<b>Committee:</b> Development	<b>Date:</b> 10 <sup>th</sup> July 2012	<b>Classification:</b> Unrestricted	<b>Agenda Item No:</b> 8.1
<b>Report of:</b> Corporate Director of Development and Renewal		<b>Title:</b> Planning Application for Consideration	
<b>Case Officer:</b> Jerry Bell		<b>Ref No:</b> PA/12/00844	
		<b>Ward(s):</b> Adjacent to St Katharine's and Wapping

**Location:** 100 Minories, London EC3N 1JY  
**Existing Use:** Former London Metropolitan University building  
**Proposal:** Demolition of the existing buildings on site and the erection of a 10-storey plus basement hotel (Use Class C1) comprising of 265 bedrooms together with ancillary restaurant, bar and retail facilities  
**Applicant:** Grange Hotel Group  
**Owner:** Grange Hotel Group  
**Historic Building:** N/A, however portions of the adjacent Roman Wall are Grade I Listed and also a Scheduled Monument.  
**Conservation Area:** The Crescent Conservation Area (City of London)

**Figure 5: Verified view of rear elevation of proposed building and screen from within The Crescent**

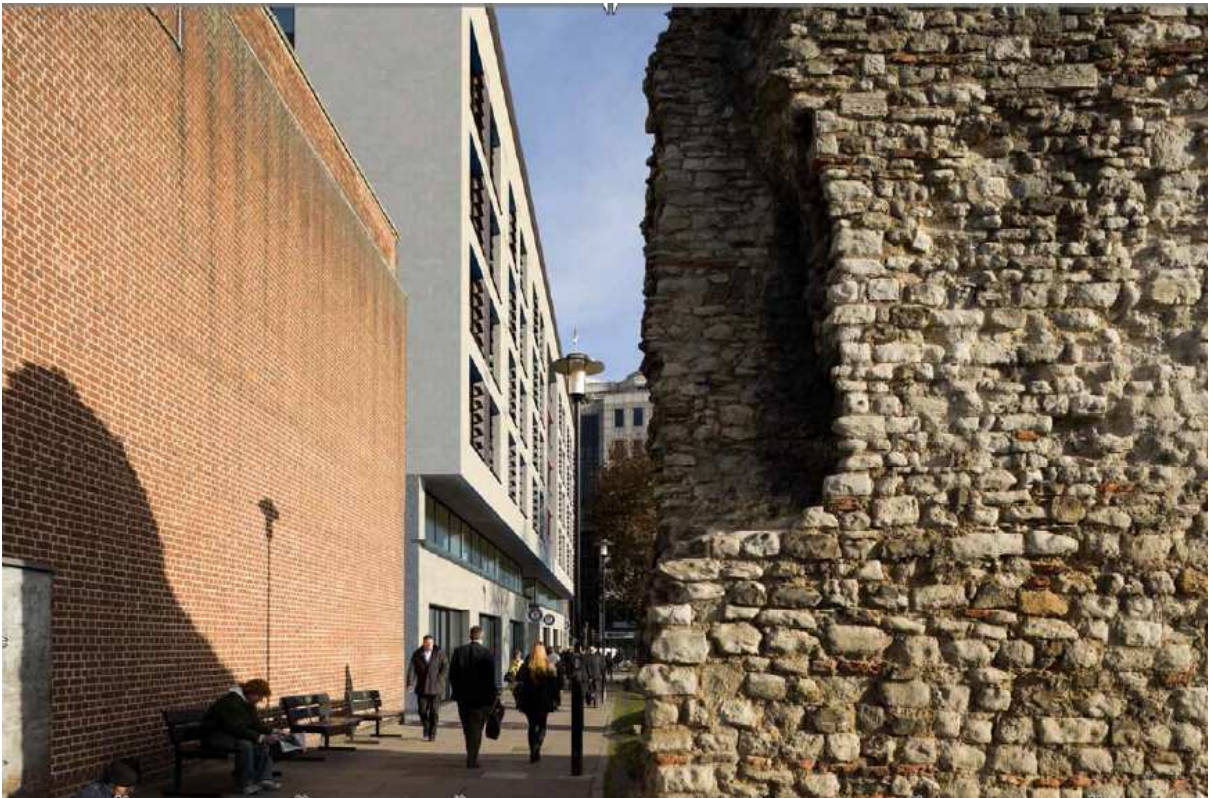
It is also considered that the proposed substation glazed screening (figure 5 overleaf) within The Crescent, would appear as an unrelieved single architectural element, harmful to the scale and setting of the adjacent listed townhouses, which would further erode the character of the Crescent Conservation Area.
